Addendum 16 – UN Regulation No. 17

Revision 6 - Amendment 2

10 series of amendments – Date of entry into force: 9 June 2021

Uniform provisions concerning the approval of vehicles with regard to the seats, their anchorages and any head restraints

Figure 1
Non-Use Warning Labels

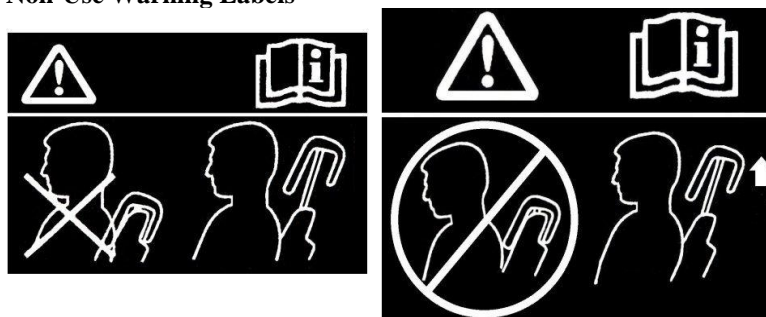
- 5.8.4.5. The presence of a non-use position of a head restraint shall be marked with a label, in the form of a pictogram which may include explanatory text. The label shall either provide an indication when the head restraint is in a non-use position or provide information to enable an occupant to determine whether the head restraint is in a non-use position. The label shall be durably affixed and located such that it is clearly visible by an occupant when entering the vehicle to the designated seating position. Examples of possible designs of pictograms are shown in Figure 1.

Figure 4-1

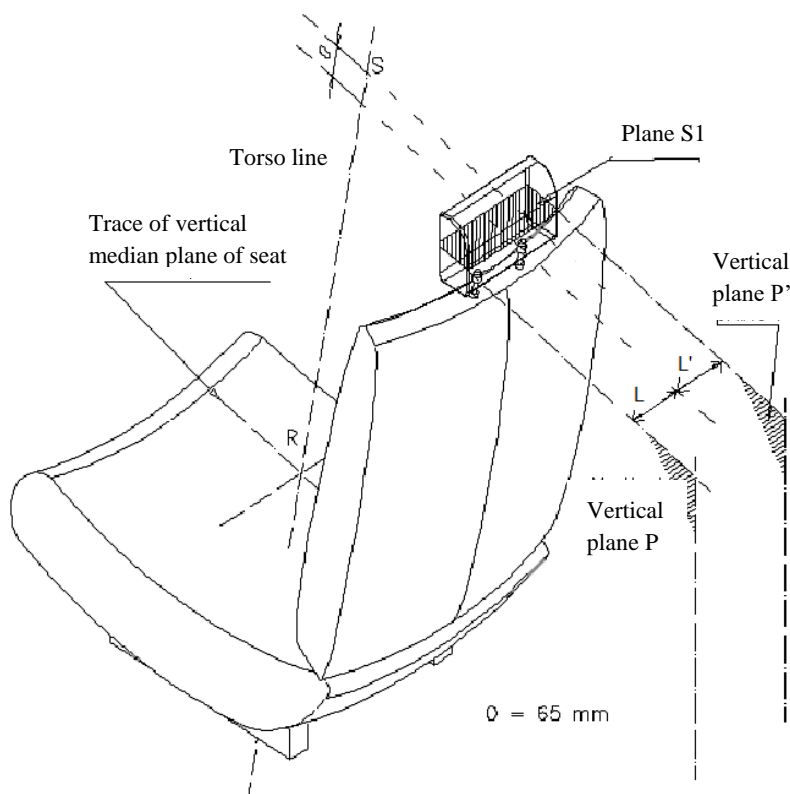
1. Purpose
The purpose of this test procedure is to demonstrate compliance with the minimum width requirements described in paragraph 5.6.3. of this Regulation.
2. Procedure for Width Measurement
 - 2.1. The seat shall be adjusted such that its H-point coincides with the R-point; if the seat back is adjustable, it is set at the design seat back angle; both these adjustments shall be in accordance with the requirements of paragraph 2.1. of Annex 11.
 - 2.2. The plane S1 is a plane perpendicular to the reference line and situated 65 ± 3 mm below the effective top of the head restraint.
 - 2.3. Planes P and P' are vertical longitudinal planes, tangential to each side of the head restraint to be measured.
 - 2.4. Measure the distances L and L' in the plane S1 between the vertical longitudinal planes passing through the torso line and the planes P and P'.

Figure 8-1
Measurement of a Vertical Gap "a"

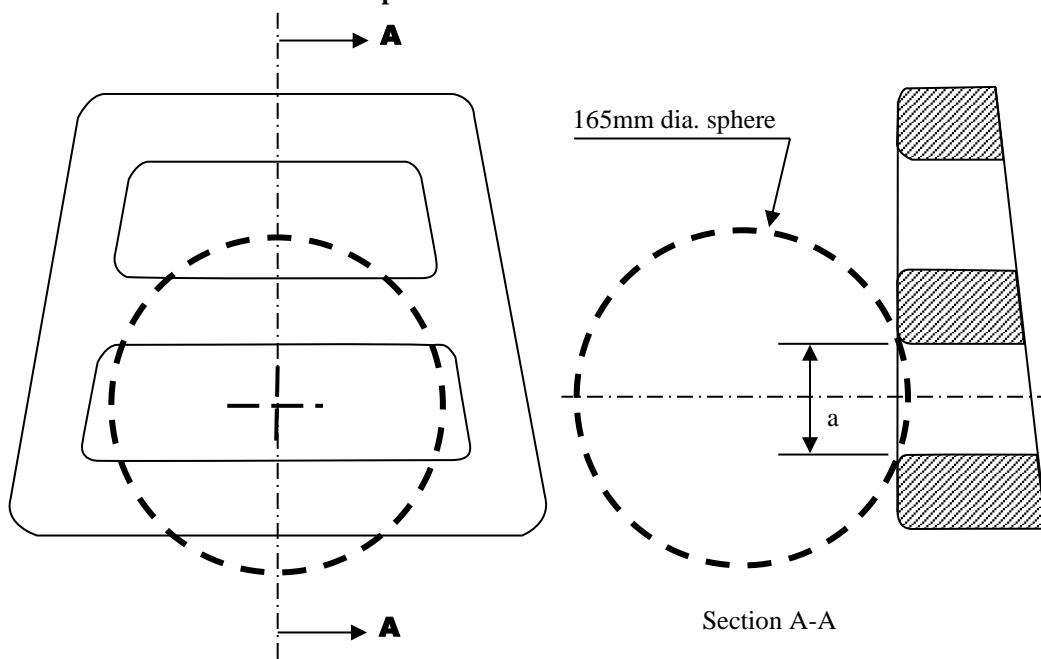
- 2.5. Determine the gap dimension by measuring the straight line distance between the inner edges of the two furthest contact points, as shown in Figures 8-1, 8-2 and 8.3.

Figure 10-6

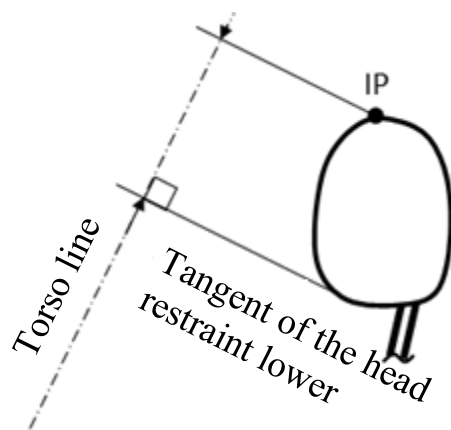
- 5.6.7. The height of the front contact surface of the head restraints, measured as described in Figure 10-6 of Annex 10 shall not be less than 100mm except for integrated head-restraints.

Figure 14-2

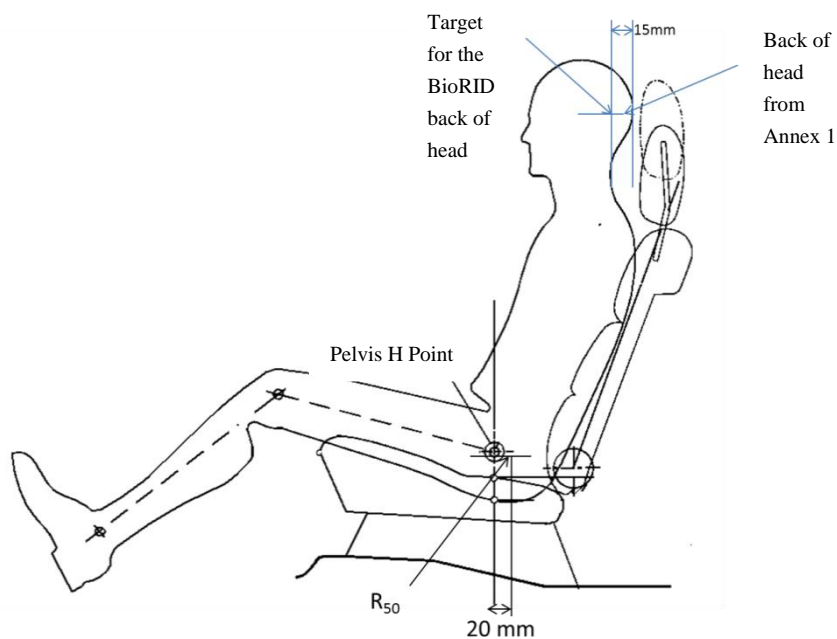
The back of the head reference position for the UN BioRID II is the value for the back of the head as determined for the 50th percentile in Table 10-1 of Annex 10 of this Regulation with reference to the specified torso angle minus 15 mm (increasing the backset as shown in figure-14-2 below).

Figure 14-3

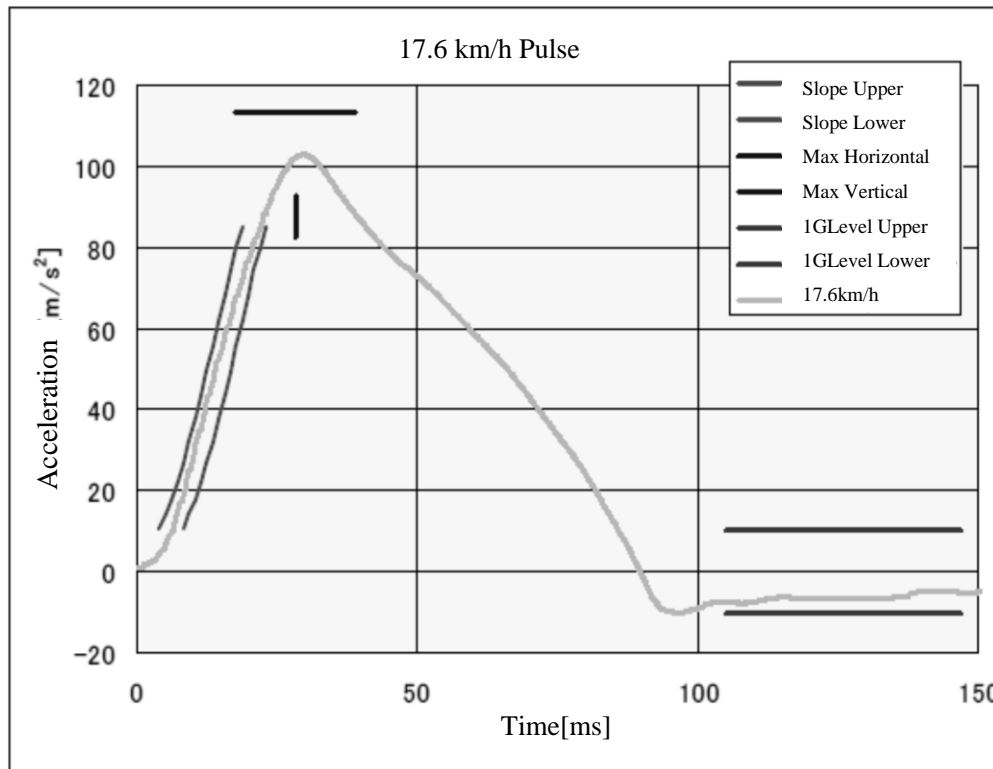
The corridors for the pulse are illustrated in Figure 14-3. The sled acceleration shall be adjusted within the corridors described in Figure 14-3 and Table 14-1 for the complete time interval from 0 to 0.15s. The sled pulse shall fulfil the requirements as specified in Table 14-2.
